**SEMINOLE COUNTY GOVERNMENT
AGENDA MEMORANDUM**

SUBJECT: Willa Grove Subdivision Wall Contribution

**Re: Review of Failed Privacy Wall
Willa Grove Subdivision
Winter Park, Florida**

**Re: Report Addendum
Review of Failed Privacy Wall
Willa Grove Subdivision
Winter Park, Florida**

Photo No. 3: Photograph shows lack of vertical reinforcing steel in failed wall section. wall.

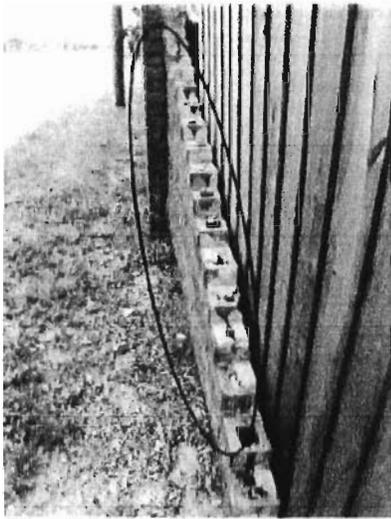
We observed that, with the exception of a section at the south end of the subdivision, the areas of the wall where failure occurred had not been constructed with reinforcing steel (Photo No. 3). Evidence suggests that the wall was built on top of the original sidewalk and that the original sidewalk was constructed with a thickened-edge footing to support the

Photo 1: Collapsed section of privacy wall where base course of masonry (right arrow) separated from concrete footing (left arrow).

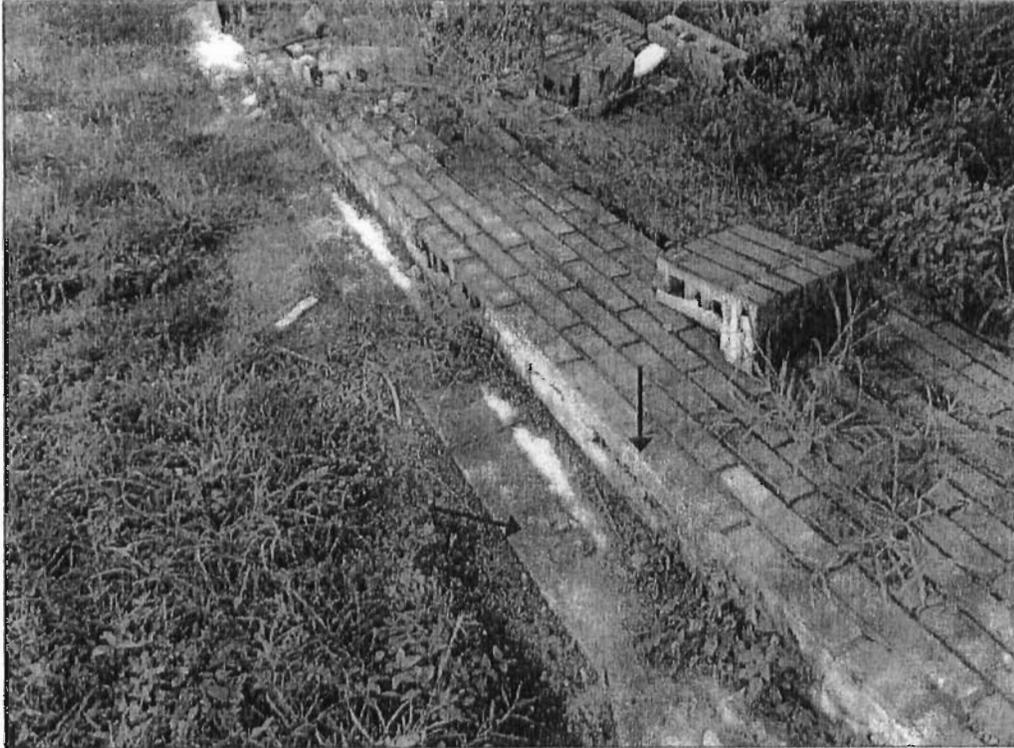
There were two basic failure modes noted during our review. One involved separation of the bottom course of masonry from the concrete foundation (Photo 1). The other involved separation of the wall along one of the horizontal mortar joints located near the base of the wall (Photo 2). Without vertical reinforcing steel, the weight of the wall and the brick-to-brick and brick-to-concrete mortar bond had to resist the entire overturning moment induced in the wall by the wind loading. Failure of the mortar bond led to collapse in both failure modes. There was minimal to no rotation of the footing observed at these locations. This is consistent with the findings at still-standing wall sections that were leaning. Based on level readings, it is estimated that the footings at these sections had rotated less than two and a half degrees. Greater rotation of the footing and wall would be expected if the primary cause of the collapse was an unstable foundation.
